Subject: Site Plan Special Permit #07/03/14 - #451 – Acton Management Inc – 267 Great Road

We have reviewed the plans titled "Site Plan for Acton Management, Inc, 267 Great Road, Acton, Massachusetts" dated June 27, 2014 for the above mentioned special permit and have the following comments:

To: Cheryl Frazier
From: Evan Carloni, Health Department
Re: SPSP #07-03-14-451 267 Great Road

RE: Comments on 267 Great Road/SPSP #07-03-14-451

Acton Ladder Truck
 Length : 38.58
 Width : 7.46
 Track : 7.06
 Lock to Lock Time : 6.00
 Steering Angle : 46.0

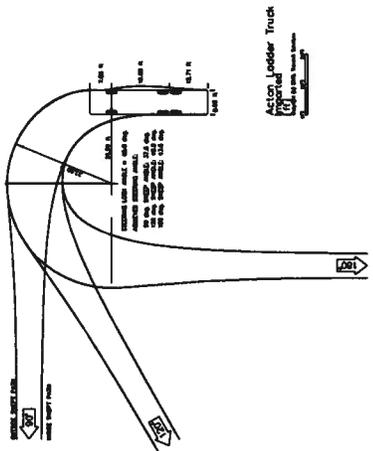
5. We request a copy of the MassDOT permit for the work shown within the road layout of Great Road for our records.
6. Based on our turning templates, an emergency SU-30 vehicle (fire truck) can maneuver within the site. Recently on another development the Fire Department has commented that the Acton ladder trucks are a different size than the SU-30 vehicle. Our office was given a copy of the ladder truck template by the applicant of the other development and we will supply that template with this memo. It appears the ladder truck would be able to maneuver within the parking area. We will defer further comment to the Fire Department.
